Objection to ABP Case Number 324290 by Scott Coombs

This submission constitutes a formal objection to the proposed Lissinagroagh Wind Farm on the grounds that the Environmental Impact Assessment Report (EIAR), specifically Chapter 13 (Landscape and Visual), is materially deficient, methodologically flawed, and fails to comply with statutory requirements under the Planning and Development Acts and the EIA Directive (2014/52/EU).

Significant viewpoints along the L2206 corridor

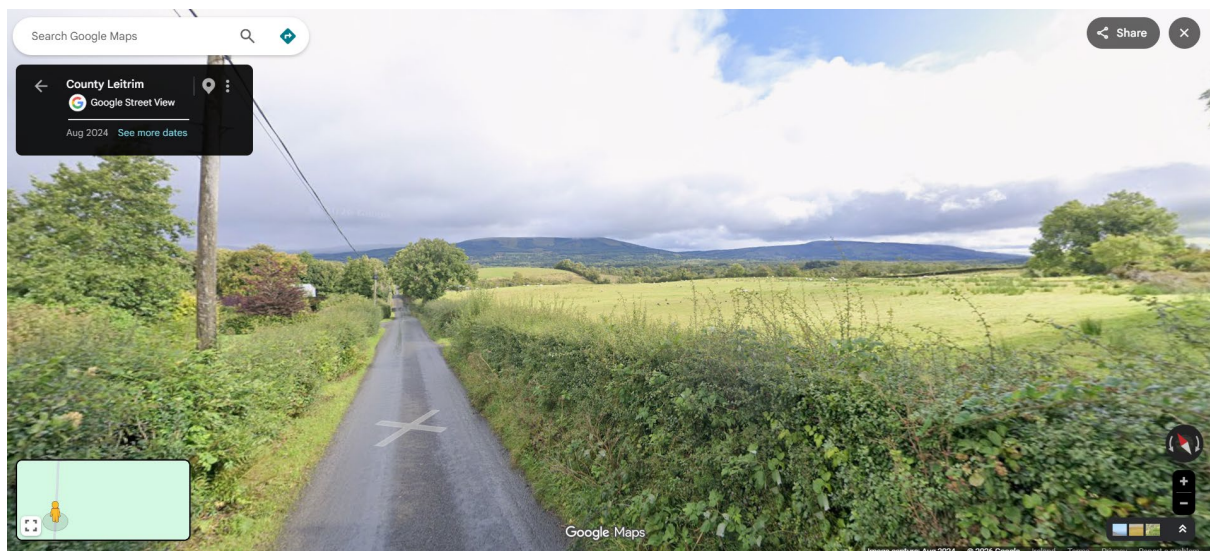
The EIAR’s failure to include this receptor constitutes a selection bias in viewpoint methodology, leading to systematic underestimation of impact.

The EIAR's viewpoint selection is flawed in that it:

- The result is a non-representative visual assessment, rendering conclusions unreliable.
